#6 SUB2007-00106

## **GOVERNMENT/AIRPORT SUBDIVISION**

<u>#6</u> SUB2007-00106

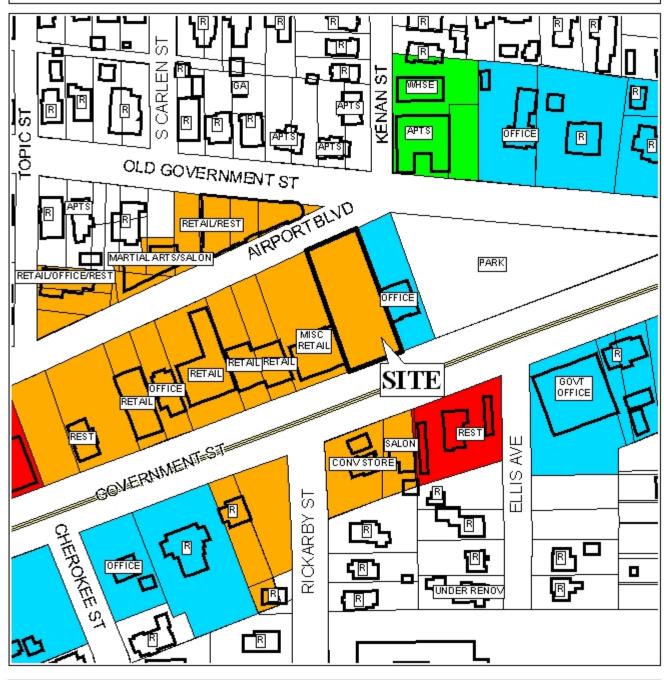
The plat illustrates the proposed  $0.5\pm$  acre, one lot subdivision, which is located on the North side of Government Street,  $165'\pm$  West of Ellis Avenue, and extending North to Airport Boulevard, in city council district 2. The subdivision is served by city water and sanitary facilities.

The site is now vacant and has been the site of a fast food restaurant, dine-in restaurant, and residence in the past. It has been zoned B-2, Neighborhood Business since the adoption of the Zoning Ordinance in 1967. The site currently has one curb cut to Government Street and two curb cuts to Airport Boulevard and allows cut-through traffic between the two streets. A note should be placed on the final plat limiting the site to one curb cut each to Government Street and Airport Boulevard with no internal through connection. Since the site has double street frontage, the 25' front setback line should be shown along both frontages. The current right of way width along Government Street is 100' and is in compliance with the Major Street Plan for such width.

1. the placement of a note on the final plat stating that the subdivision is limited to one curb cut each to Government Street and Airport Boulevard, size, location and design to be approved by Traffic Engineering and ALDOT, with no internal through connection; and

2. the depiction on the final plat of the 25' front setback line along Government Street and Airport Boulevard.
